SAFETY EVALUATION REPORT
RELATED TO THE TOPICAL SAFETY ANALYSIS REPORT
FOR THE NAC STORAGE/TRANSPORT CASK, REVISION 2,
SUBMITTED BY NUCLEAR ASSURANCE CORPORATION

U.S. Nuclear Regulatory Commission

Office of Nuclear Material Safety and Safeguards

March 1988

FIGURE 2-1: SPENT FUEL CLAD MAXIMUM TEMPERATURE VS DECAY TIME (NAC S/T)

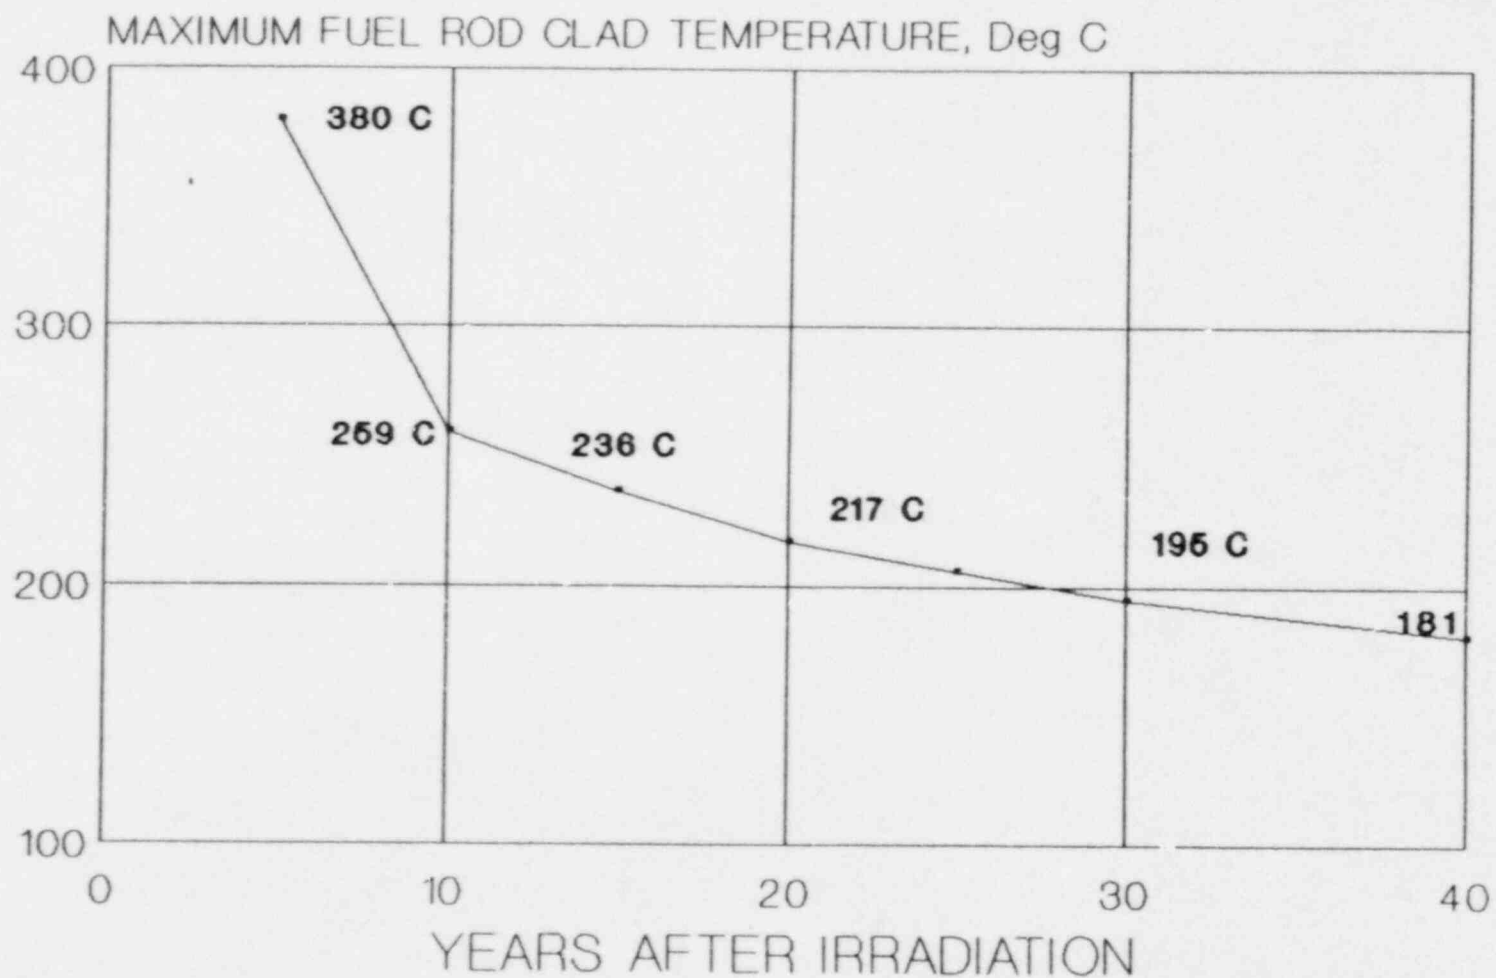
The system reviewed consists of pressurized Zircaloy cylinders in an inert helium atmosphere. The thermal environment is characterized in the TSAR by an initial temperature of 360°C (680°F) which decays over time in accordance with the curve shown in Figure 4.8-27 of the TSAR. However, an independent analysis

performed by the reviewers indicates that the initial storage temperature is 380°C. The reviewers assumed that the decay curve is parallel to the one provided in Figure 4.8-27, but 20°C higher and leveling off at 150°C.

The temperature dependence of grain boundary decohesion was established using the temperature decay curve provided in Figure 4.8-27 of the TSAR. These temperatures were adjusted upward by 20°C for use in this analysis in the SER, because of the review of the thermal analysis discussed in Section 4.1.4 of this TSAR. See Figure 2-1.
